Project Summary for the  
Planned Issuance of a Revision to  
Construction Permit/PSD Approval 95010001  
to Accommodate an Emissions Reduction Project at  
United States Steel Corporation's Granite City Works  
Granite City, Illinois

Source Identification No.: 119813AAI  
Construction Permit Application/Permit No.: 95010001

Attachment 2: Mark-Up Showing Planned Changes to Permit 95010001

ATTACHMENT A

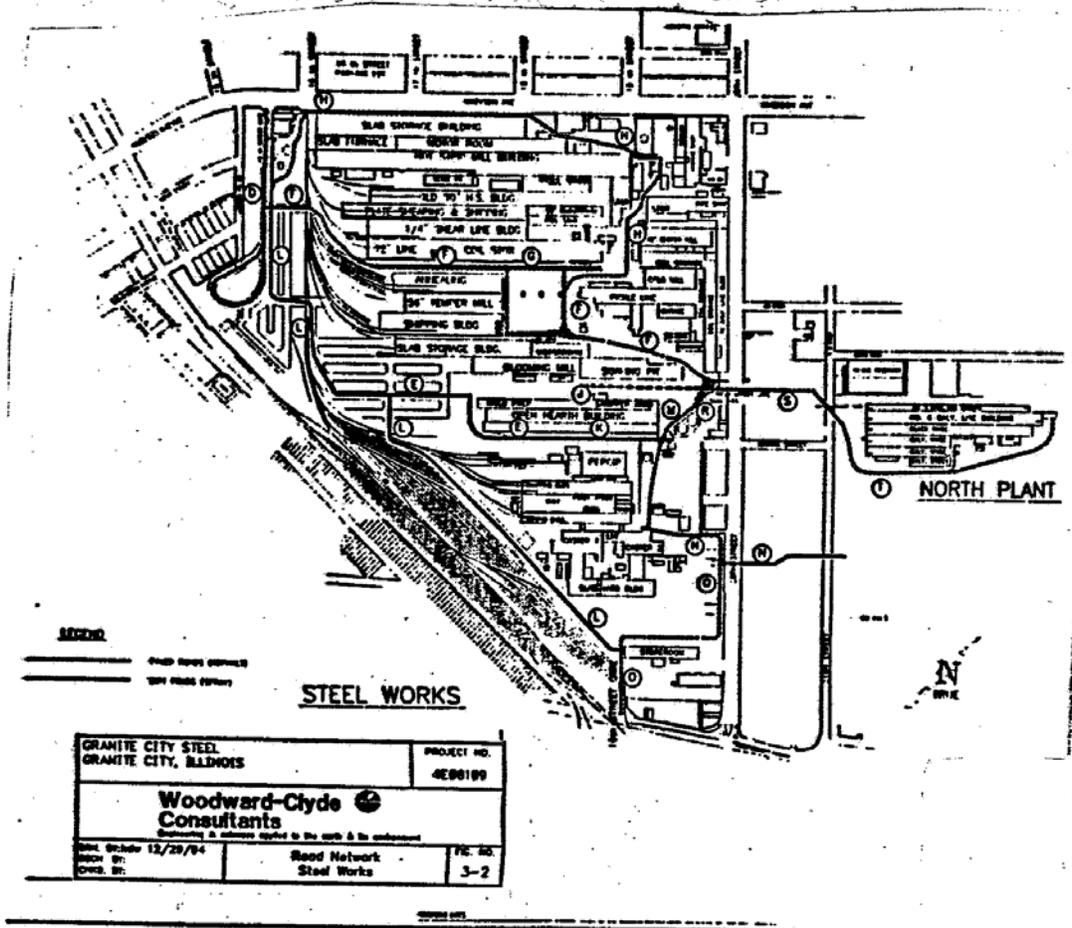
(Former Attachment A has been removed in this revised permit.)

~~PROCEDURES TO ENSURE PROPER OPERATION  
OF BOF ESP CONTROL SYSTEM~~
